# VEHICLE RECALL

G-02506  
NOVEMBER 2002

**SUBJECT: VEHICLE SAFETY RECALL (U.S., EXPORT)**

**Installing a repair kit on straight trucks to eliminate the air brake fitting that connects the double check valve to the relay valve on certain 2000, 4700, 4800, 4900, 5000, 8000, 9000 series built from 12/16/97 through 03/04/02**

**Figure 1: Most Common Original Relay Valve and Double Check Valve Assembly With the Subject Fitting**

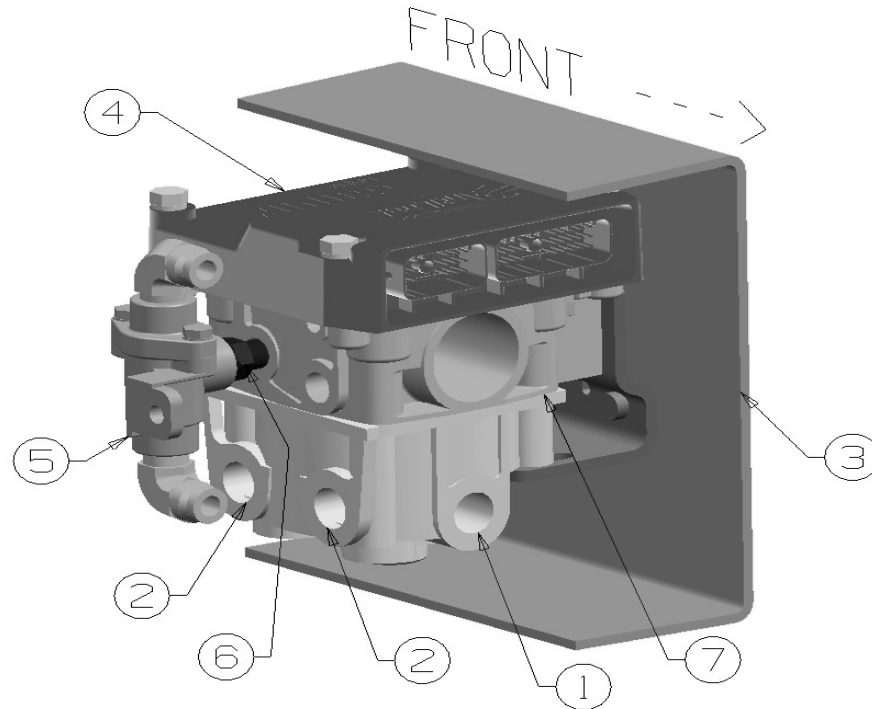
The straight fitting (shown as item 6 in Figure 1 and Figure 2) that connects the double check valve to the rear axle brake relay valve may break. With certain forces placed upon the vehicle, the weight of the check valve on the fitting can cause the assembly to resonate. The subsequent vibration can cause excessive strain levels in the fitting, which could eventually cause a fatigue failure.

**DESCRIPTION:** The vehicles that need this recall repair **WILL HAVE** the fitting (item 6 in Figure 1 or Figure 2) and the external double check valve (item 5 in Figure 1 or Figure 2) and must have one of the two recall repair kits installed. **If a vehicle DOES NOT have items 5 and 6 shown in Figure 1 or Figure 2, DO NOT complete the service procedure, report the vehicle as inspected and no corrections necessary (disposition or cause of 1).** The correct instructions are identifiable by kit number. Be sure to follow the correct service procedure for the kit being installed.

4. Drain the air tanks.
5. Disconnect both air lines from the double check valve shown in Figure 1.
6. Remove the double check valve and the straight fitting (items 5 & 6) from the relay valve, reference Figure 1.

**Kit 8900083R91 (bracket kit):** 98% of the vehicles in this recall will use this kit. The kit contains brackets and hardware designed to replace the subject fitting with a short flexible air line (see Figures 3 & 4). Some vehicles may require additional bolts to be ordered with this kit. The number of vehicles requiring these special bolts is very small (see the PART INFORMATION section of this letter).

- If the vehicle rear axle relay valve **DOES NOT** have items 5 and 6 above, it **DOES NOT** need the recall procedure performed.
- A few vehicles will have remote mounted ECU's. In this case, the relay valve will have a plate mounted on top of the valve instead of an ECU.

**Figure 2:**      **Alternate Original Relay Valve and Double Check Valve Assembly with the Subject Fitting**

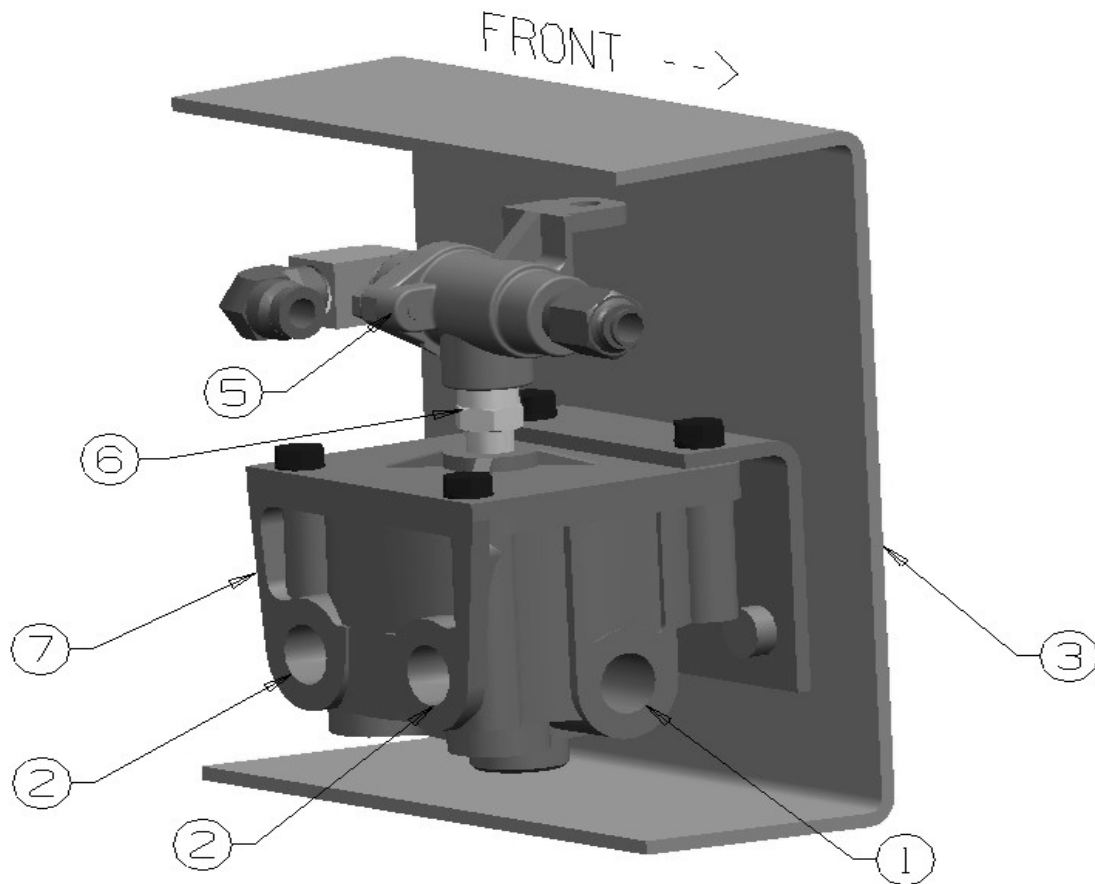
4. Drain the air tanks.
5. Make note of the supply and delivery air line positions, because they must be reinstalled in the same relay valve ports as they were originally (Figure 2).

**Kit 8900084R91 (valve kit):** Only 2% of the vehicles in this recall will use this kit. The valve kit contains a new air brake relay valve (R12DC) with an internal double check valve, and new fittings (see Figure 5). When these kit parts are installed, the external double check valve and the subject fitting, items 5 and 6 in Figure 2, are eliminated. Figure 5 shows a representation of the new relay valve and the location of the air line control ports.
